Contract No. T200411209.01
Federal Aid Project No. ESTP-S028(8)
SR 24, Mulberry Knoll to SR 1
Sussex County

Enclosed is Addendum No. 1 for the referenced contract consisting of the following:

Addendum No. 1
October 24, 2019

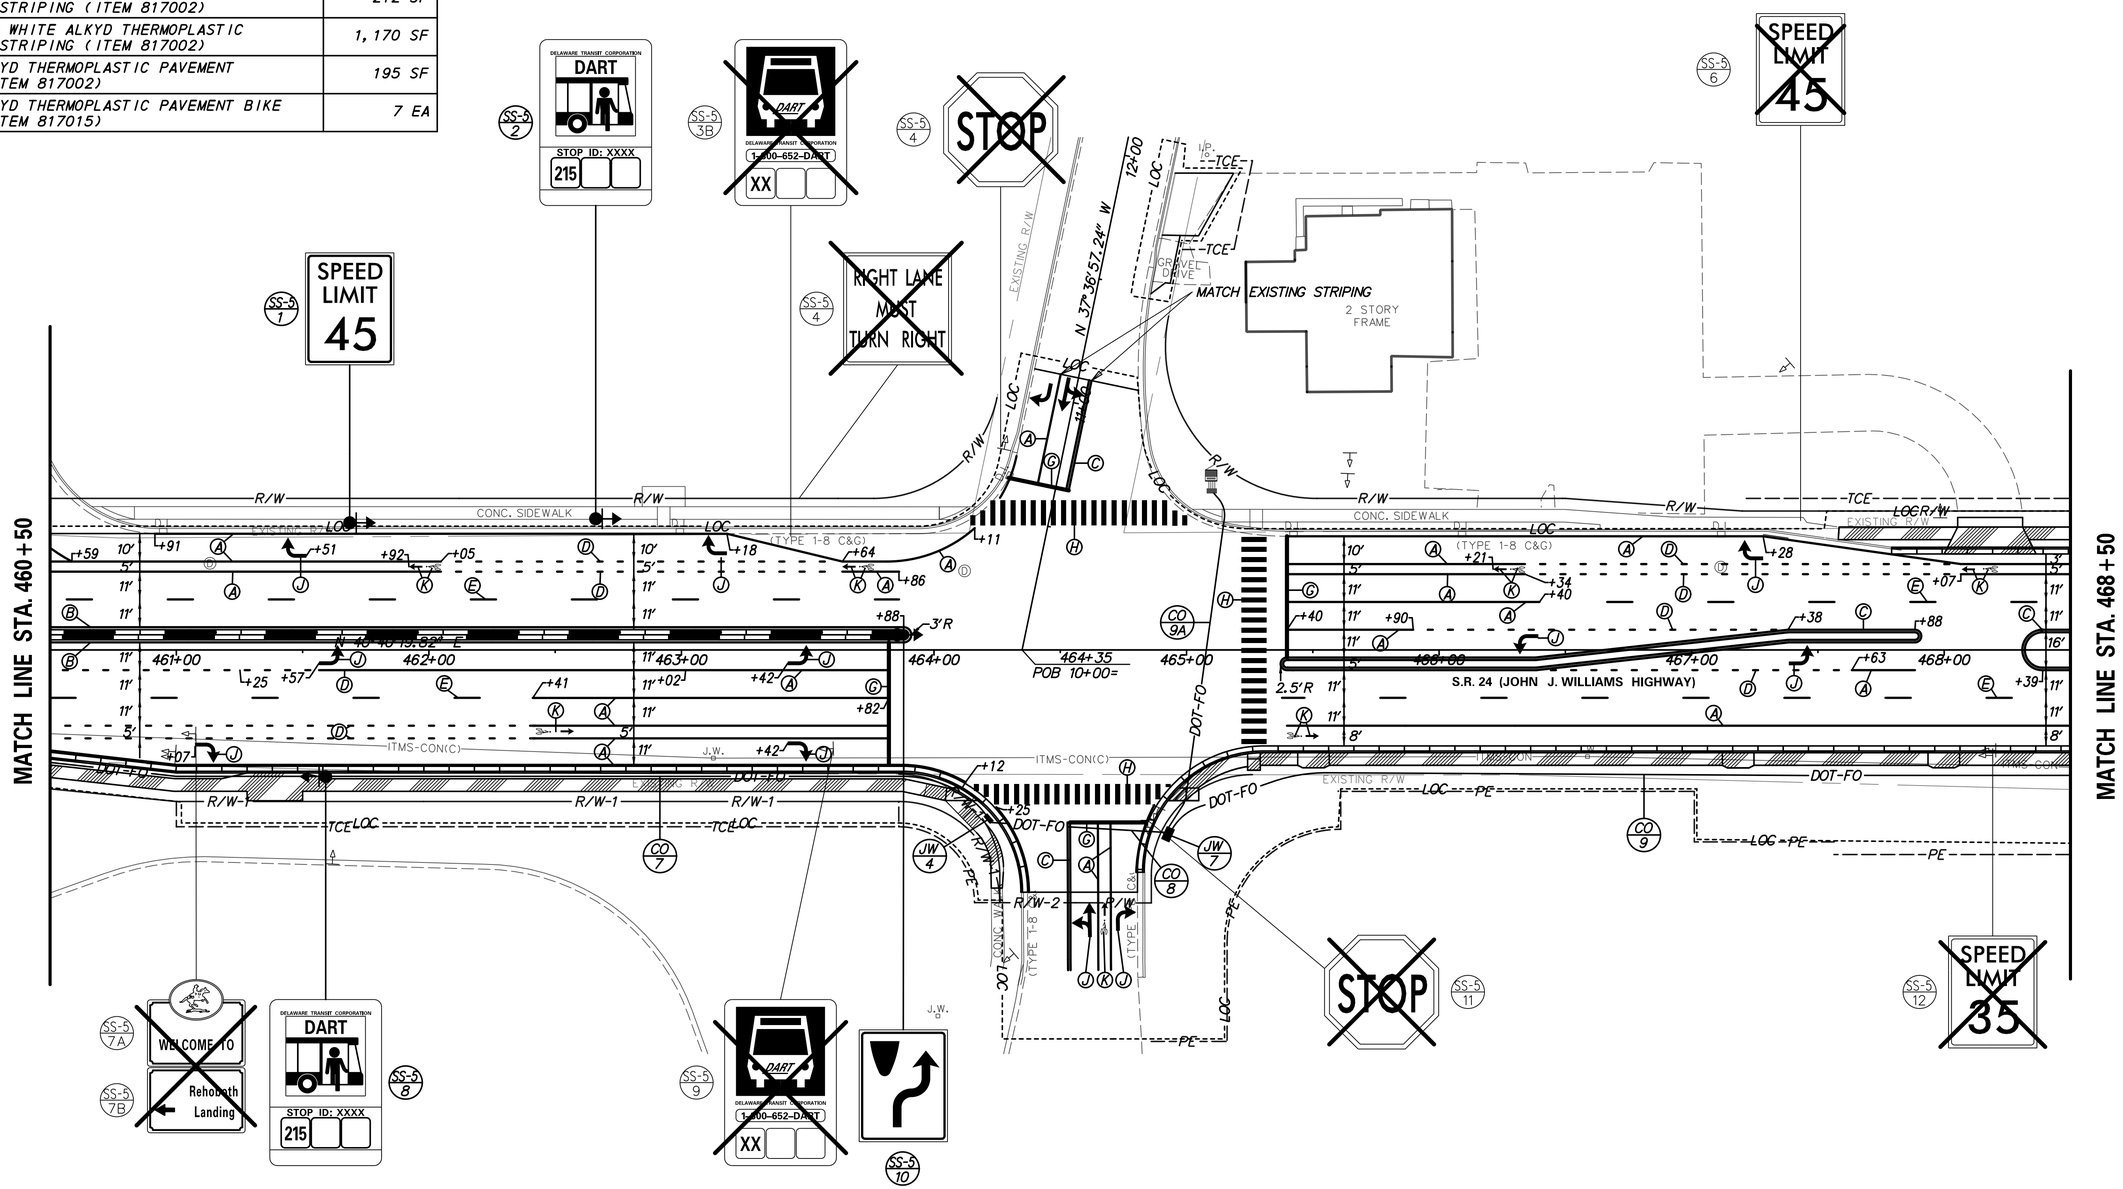
ADDENDA / REVISIONS		
1 REVISED DRIVEWAY LAYOUTS	D. SEMPLE 10/03/2019
